BASILDON TOWN CENTRE HIGHWAYS IMPROVEMENTS

COMBINED STAGE 3 & 4 ROAD SAFETY AUDIT

Report Date:	13 th February 2024
Road Safety Audit Register Number:	9286
DM Code:	N/A
Project ID:	16233102230400008

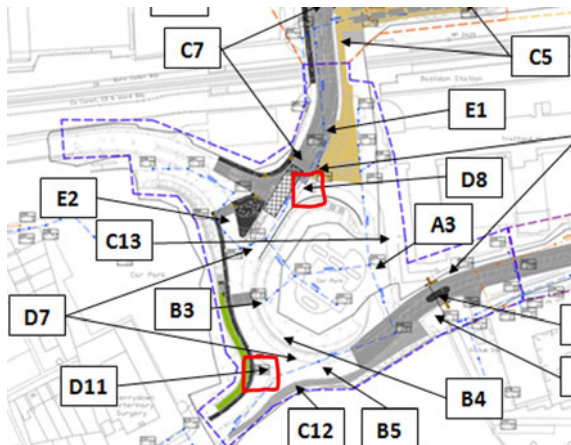
During the Stage 3-4 site visit it was noted that there are several 'Turn Left' regulatory signs and carriageway marking to direct road users. However, at the time of the site visit, the vehicle in the image below was observed turning right into Station Way. It is recommended that this issue is monitored and remedial / enforcement actions taken as appropriate.

Image No.2

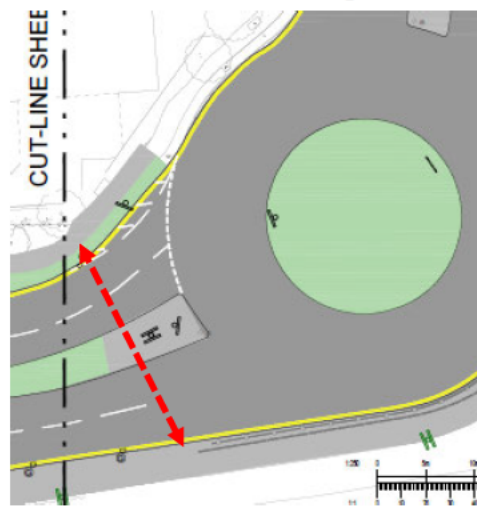
Summary: Risk of pedestrians colliding with road users due to no pedestrian crossing.

The existing highway layout includes pedestrian guardrail on the northern and southern footways of Southernhay, as well as along the central reserve of the dual carriageway. During the site visit the Audit Team observed a number of pedestrians crossing Southernhay by climbing over the pedestrian guardrail from the north side to gain access to the south side, as indicated by the brown arrow in Image No.2. This increases the potential for pedestrians to collide with road users who may be entering or leaving the roundabout, particularly as drivers would have their attention drawn to the roundabout and other traffic using it, especially when observing the access to the ASDA superstore.

It is recommended that the designer should review the likelihood of pedestrians wishing to access the footway/footpath links east of the roundabout in question, with a view to including pedestrian facilities.

Image No.4

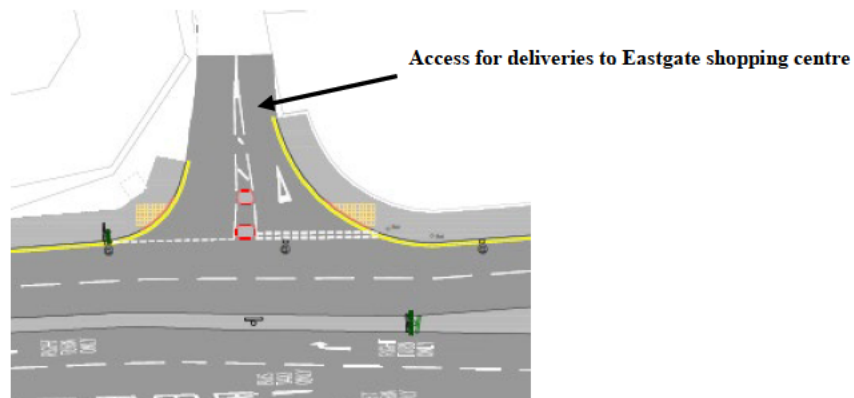
Summary: Risk of collisions between vehicles and partially sighted pedestrians due to no tactile paving guidance.

The drawing submitted for audit proposes two traffic islands where pedestrians may wait for traffic to access the Eastgate shopping area. These islands would form a safe haven for crossing pedestrians. However, no tactile paving is proposed between the two traffic islands. This would be a particular issue for partially sighted pedestrians who would be following the orientation that the tactile paving either side of the junction would give them. Partially sighted pedestrians may not be aware of the two traffic islands and may continue through the junction until they reach the opposite side. Consequently, there is a risk of pedestrians colliding with vehicles exiting or entering the delivery access to Eastgate shopping centre, which may result in injuries to pedestrians.

Image No.5

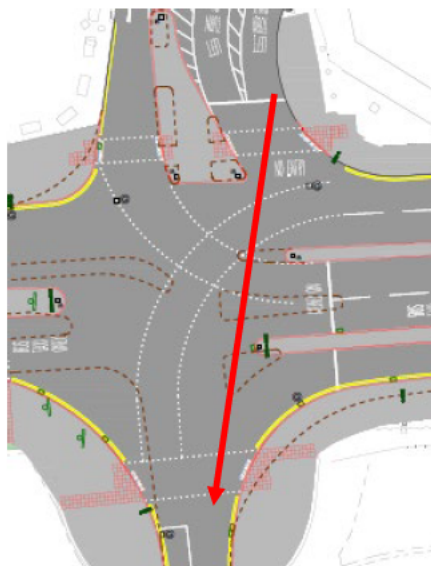
Summary: Risk of vehicle side impact collisions due to vehicles exiting multi-storey car park.

The drawing submitted for audit shows two lanes exiting the multi-storey car park above the Eastgate Shopping Centre. The design suggests that the median strip separating the traffic lanes will be reduced eastwards. The amendments to the junction are as a consequence of the reconfiguring of the junction. However, the reduction of the median separating island provides the potential for vehicles exiting the multi-storey car park to travel across the junction southwards and continue their journey along Clay Hill Road. (The suggested direction of the potential risk is shown by a red arrow). The result of this issue is that there is a risk of vehicle side impact collisions, with the potential of serious injuries occurring or even fatalities.

Image No. 8

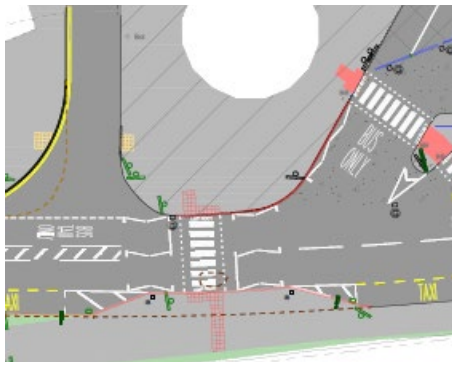
Summary: Risk of collisions between pedestrians and vehicles.

Image No.8, which is an extract from drawing number 14916-100-WIE-ZZ-DR-C-900103 Rev P01, shows a proposed controlled pedestrian crossing point on Southernhay, adjacent to a retail unit called The Barbers Shop. The tactile paving shown in image No.8 illustrates a proposed standard L shaped layout for this facility on the north side of Southernhay. However, the stem of the tactile paving layout is too short for visually impaired pedestrians, who may bypass the tactile unaware of the controlled crossing point available, leading to them cross the road at an inappropriate location, increasing the risk of injury should a collision with a vehicle occur.

Agreed: The crossing has been reviewed and a changes to the tactile paving due to the change to an uncontrolled crossing point.

Image No. 10

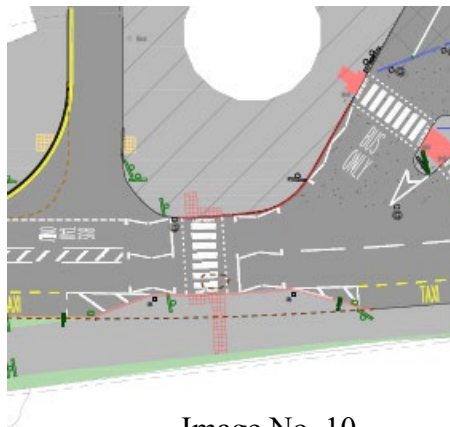
Summary: Risk of collisions between pedestrians and cyclists due to confusion of shared facilities.

The southern side of the controlled crossing point shown in image 10 above appears to be a shared footway / cycleway facility. Unfortunately, due to a lack of shared use information submitted, it is not clear whether the controlled crossing is meant for pedestrians as well as cyclists. It is assumed due to the tactile paving shown that the crossing facility is meant for pedestrians. This confusion raises the potential for collisions between pedestrians and cyclists, which may result in injuries.

Accepted: Tactile paving has been added to the southern side of Southernhay to indicate the end of the shared footway either side of the crossing point.

Image No.12

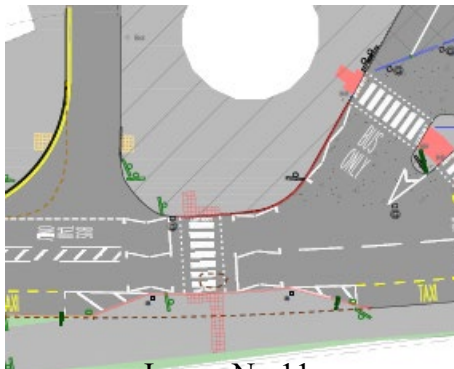
Summary: Risk of pedestrian collisions with Statutory Undertakers Apparatus.
Statutory Undertakers Apparatus

Image No. 12 above shows two Statutory Undertakers' apparatus cabinets at the approximate location where the controlled pedestrian crossing would be on the north side of South-ernhay. The drawing submitted for audit did not have this equipment shown. If the cabinets were to remain, they may physically obstruct pedestrians using the controlled crossing and/or affect visibility. This situation would be a particular problem for visually impaired pedestrians, and they could quite easily collide with the cabinets, if they were to remain, when using the crossing.

Image No.13

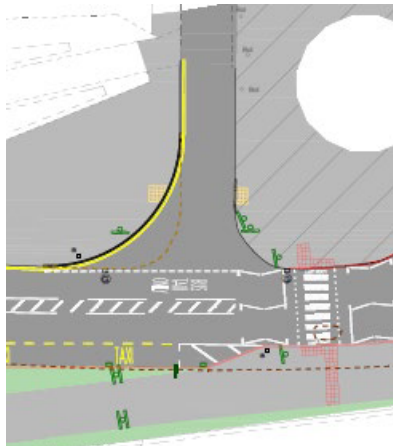
Summary: Risk of vehicle to pedestrian collisions
Southernhay

The entry radii to Market Pavement is being increased to provide a smoother sweep for vehicles exiting Southernhay. This is likely to increase the speed at which vehicles exit Southernhay, which could increase the risk of a collision with pedestrians crossing this arm, especially eastbound pedestrians who will need to turn 180 degrees to observe approaching vehicles.

Image No. 15

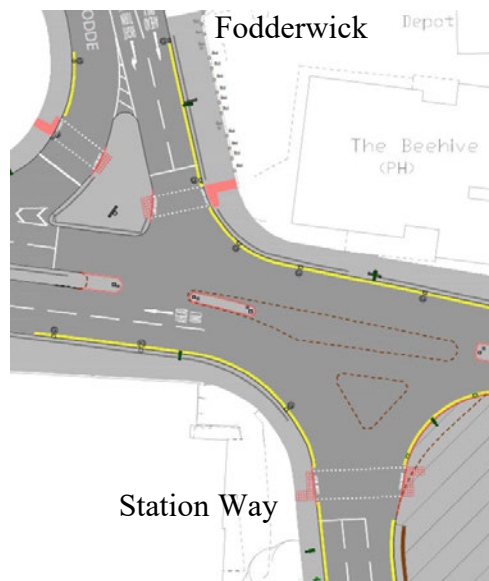
Summary: Risk of head-on and / or side impact collisions due to driver confusion.

It is proposed to alter the existing controlled junction shown in the above image No. 15, where Station Way changes from a one-way carriageway to a two-way carriageway that allows vehicles to travel from Fodderwick and Southernhay south to Station Way. The Audit Team are concerned that vehicles travelling south from Fodderwick to Station Way may misalign themselves and cause a head-on collision.

Rejected: There is a bollard proposed for the new traffic island to advise drives from Fodderwick Road to keep left. Carriageway arrow markings have also been provided to reinforce vehicle movements, as demonstrated within the drawing.

Image No. 16

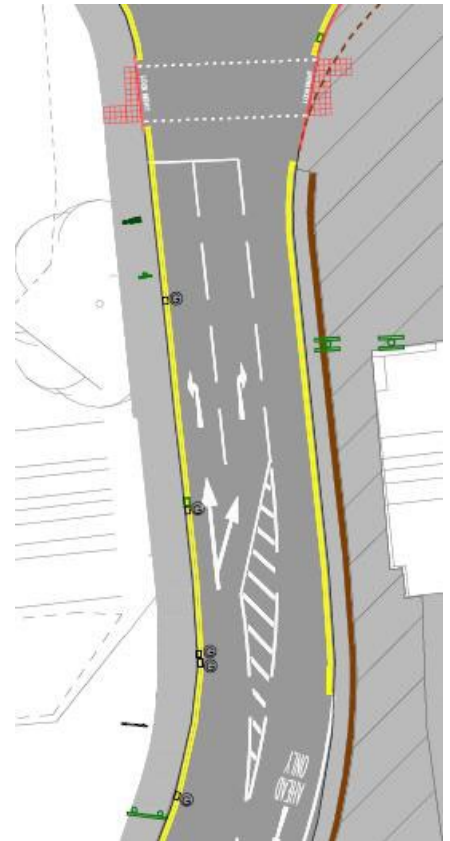
Summary: Risk of head-on and / or side impact collisions due to a change in priority for the junction resulting in driver confusion.

The drawing submitted for audit shows a change in priority at the junction and in particular Station Way where the existing configuration is a one-way priority from south to north. The proposal shown in image No. 16 shows that there will be two lanes for vehicles wishing to travel south to north, who would have to either turn left or turn right along Southernhay. The third lane would be for drivers wishing to access Station Way from Southernhay and Fodderwick to travel south. There does not appear to be any information for drivers northbound (along the previous one-way road) to inform them that the road now operates two-way. Drivers who frequently drive this route may fail to notice/observe the change in priorities. This significantly increases the risk of head on collisions.

It is recommended that significant measures are installed to inform drivers of the change of priorities/direction of travel, possibly including; physical islands, hatched centre-lines, arrow road markings at frequent intervals, warning signs and temporary 'New Road Layout ahead signs' with appropriate wording to inform drivers of the specific layout change.

Image No. 17

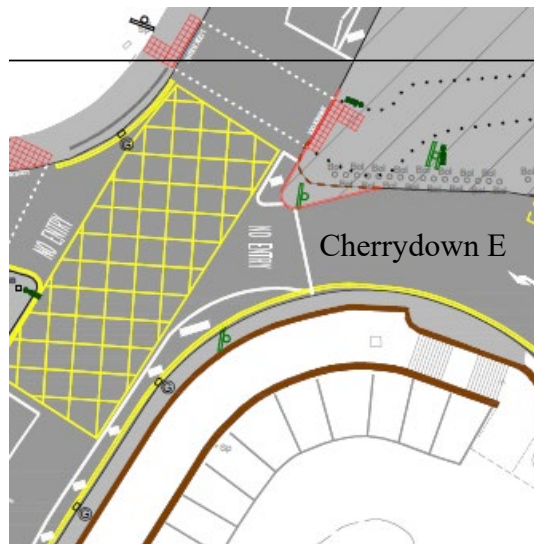
Summary: Risk of side impact vehicle collisions due to lack of visibility

The drawing submitted for audit shows the north-eastern exit from the Cherrydown East roundabout with a stop-line, which suggests that this arm of the junction is to be signalised. However, no additional information has been submitted to confirm this. The required vehicle movement is also 'left turn only' from Cherrydown East. If this arm is not signalised, there is a lack of visibility due to the retaining wall, to see vehicles travelling southbound on Station Way. As a consequence of this issue there may be the potential risk of side impact vehicle collisions, which may result in injuries.

CLIENT'S COMMENT: Agree, junction signalised

Image No.18

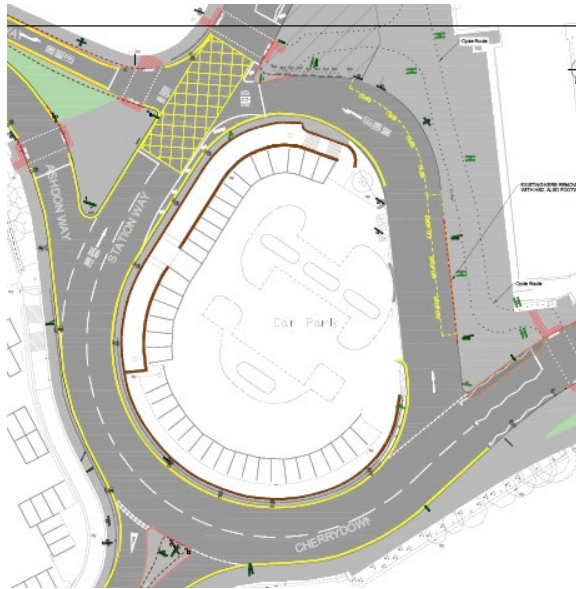
Summary: Risk of head-on and side impact collisions due to driver confusion

The above image, which is an extract from drawing No. 900105 Rev PO1, shows Station Way and Cherrydown East to change from one-way priority to two-way priority. The existing carriageway is very wide and operates as one-way. As such, elevated speeds and vehicles taking the racing line were observed. If this route is made two-way there is a risk that drivers may retain their previous habits and fail to observe that it is now a two-way road, still driving at elevated speeds and taking the racing line. This, combined with the reduced forwards visibility for southbound traffic, increases the risk of head on collisions.

Image No.19

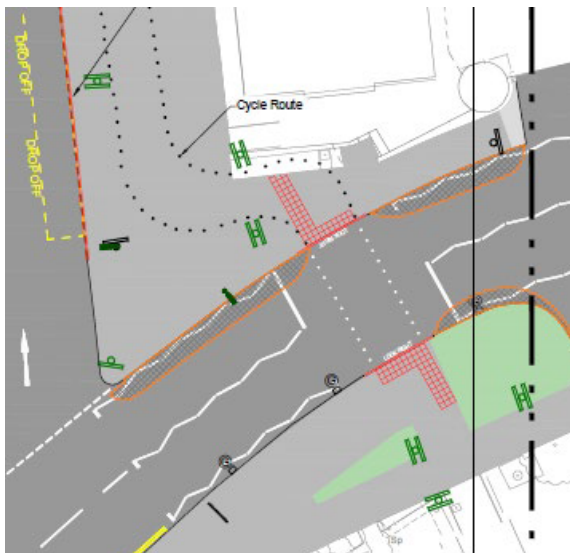
Summary: Risk of Pedestrian, Slip, Trips and Falls due to incorrect kerb levels

A toucan crossing is shown on images No. 19 and 20 above. The site visit revealed that ‘pond-ing’ had taken place during recent rainfall. This was identified by detritus being deposited at the northeast corner of the southern crossing point. There is a risk of pedestrians slipping or tripping when crossing during inclement weather and falling onto the carriageway. This is particularly significant with regard to visually impaired pedestrians.

It is recommended that mitigation measures are carried out to remove the ponding issue.

During the Stage 3-4 site visit no ponding issues were noted. No further comment.

Image No.22

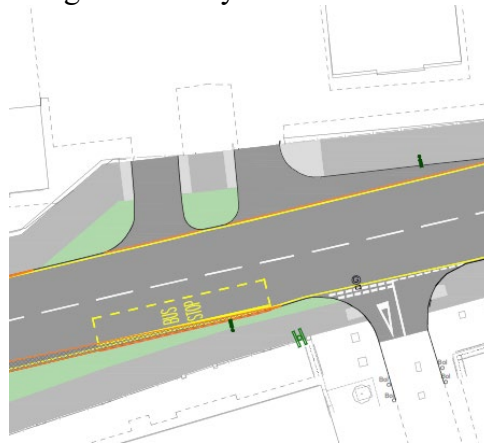
Summary: Risk of head-on collisions due to lack of visibility

The drawing submitted for audit, of which image No. 22 above is an extract, shows a proposed bus 'cage' in yellow on the Southernhay carriageway. No information has been forwarded to the Audit Team to show if there is sufficient visibility to look past a stationary bus at the bus stop. This matter affects vehicles exiting the residential area opposite Trafford House and wishing to turn left as may not be able to see if there are any vehicles travelling along Cherrydown East in an easterly direction. As a consequence of this issue there may be the potential risk of vehicle head-on collisions when overtaking a stationary bus.

It is recommended that the designer ensures that there is sufficient visibility for drivers to see past a stationary bus. If there is not sufficient visibility, then it is recommended that the bus stop is relocated to a more appropriate location or that the centre-line is appropriately re-aligned past the bus stop to provide a through lane, should the carriageway widths allow.

CLIENT'S COMMENT: Agree; there are also very infrequent bus services.

Image No. 23

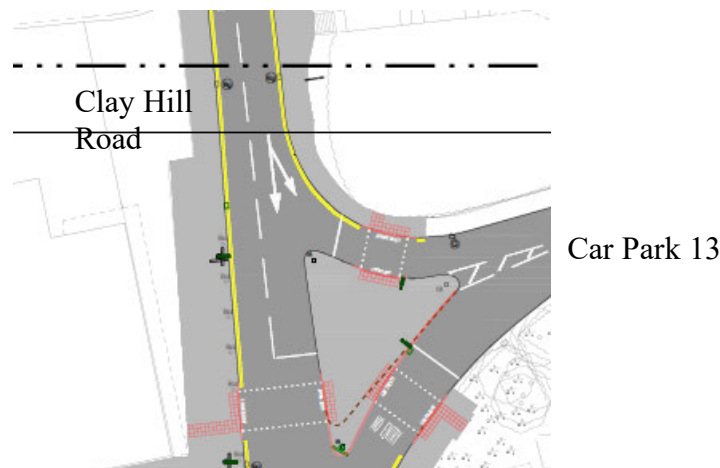
Summary: Risk of vehicle rear shunt type collisions due to driver confusion

The extract from drawing number 14916-100-WIE-ZZ-DR-C-900107 Rev P01, shown above, suggests that the pedestrian crossing will be signalised for vehicles wishing to enter Car Park 13. The location of the stop-line is such that vehicles are likely to back up and block the through-flow of traffic on the main road, leading to rear end shunts. As the proposed signal phasing has not been provided, the audit team cannot establish the proposed phasing of the junction. Additionally, there is also the potential that drivers wishing to travel south along Clay Hill Road may overtake waiting vehicles wishing to access the car park, with the risk of head-on collisions with road users travelling northwards towards Southernhay, as it is proposed that Clay Hill Road will become a two-way road.

Rejected: The junction is signalised in part to provide a safe crossing point for pedestrians, which will continue to include the entrance into Car Park 13. The staging diagrams will be provided to the Audit team for review.

Image No.24

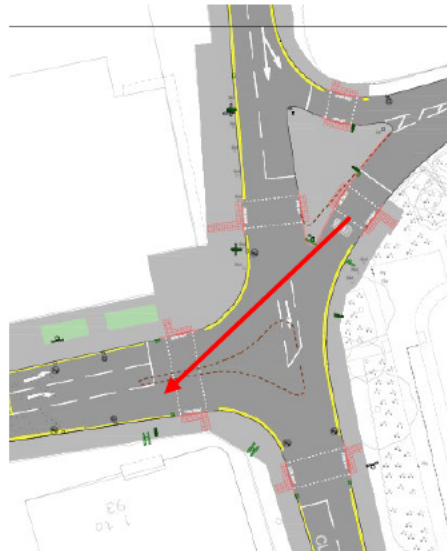
Summary: Risk of head-on collisions due to driver confusion

The drawing submitted for audit shows the proposed signalised Clay Hill Road/Cherrydown East/Car Park 13 junction. Currently, drivers exiting Car Park 13 enter Cherrydown East as a one-way road. The proposals make Cherrydown East a two-way road. Drivers may exit Car Park 13 out of habit, taking the racing line, which increases the risk of a head on collision with eastbound traffic on Cherrydown East. A possible conflict point may be point A shown in image No. 24.

Rejected: The junction is to be signalled controlled with the exit from Car Park 13 having clear indication when it is safe to go, along with clear carriageway markings to show where oncoming traffic will be or should be waiting at the time.

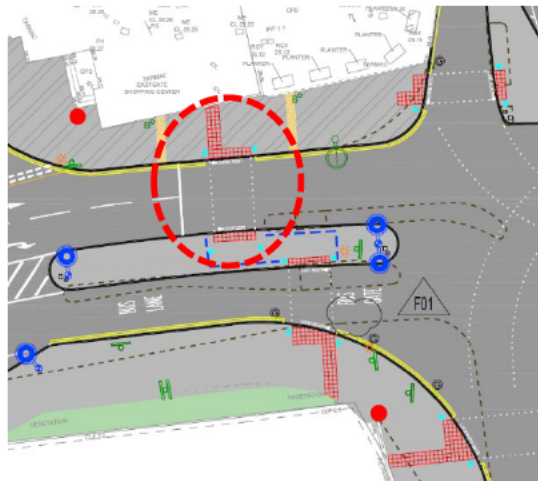
It is recommended that pedestrian guard rail is provided adjacent to the existing VRS, to deter this NMU movement.

Agree: A section of pedestrian guardrail should be installed to deter crossings at this location. 30-40m adjacent to the existing VRS on the south side of Southernhay Road
